Public Service of New Hampshire

SEABROOK STATION
Engineering Office:
1671 Worcester Road
Framingham, Massachusetts 01701
(617) - 872 - 8100

April 25, 1983
SBN-502
T. F. B7.1.2

Subject: Response to SER Outstanding Issue #7 (SER Section 4.4.5.2, Core
Performance Branch)

FIGURE 1
RCS FLOW CALORIMETRIC SCHEMATIC

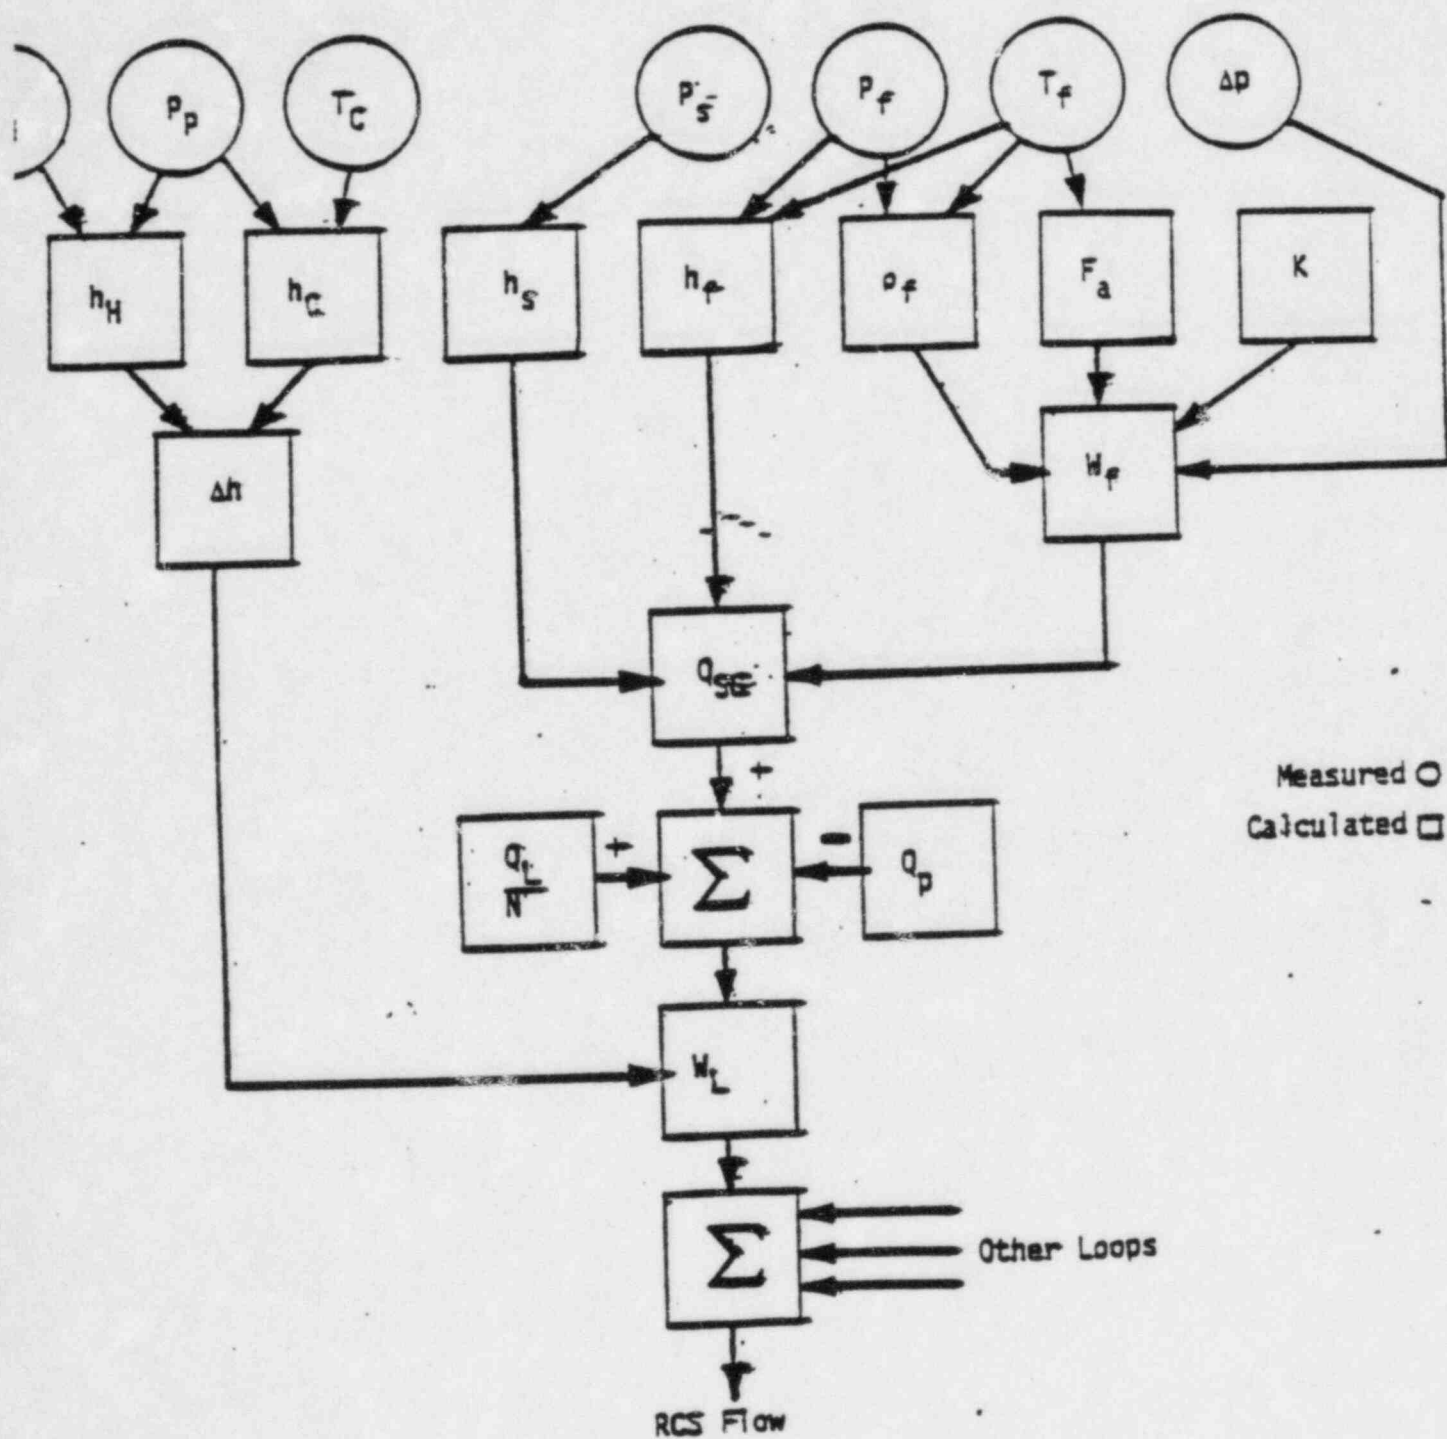
These measurements and calculations are presented schematically on Figure 1.
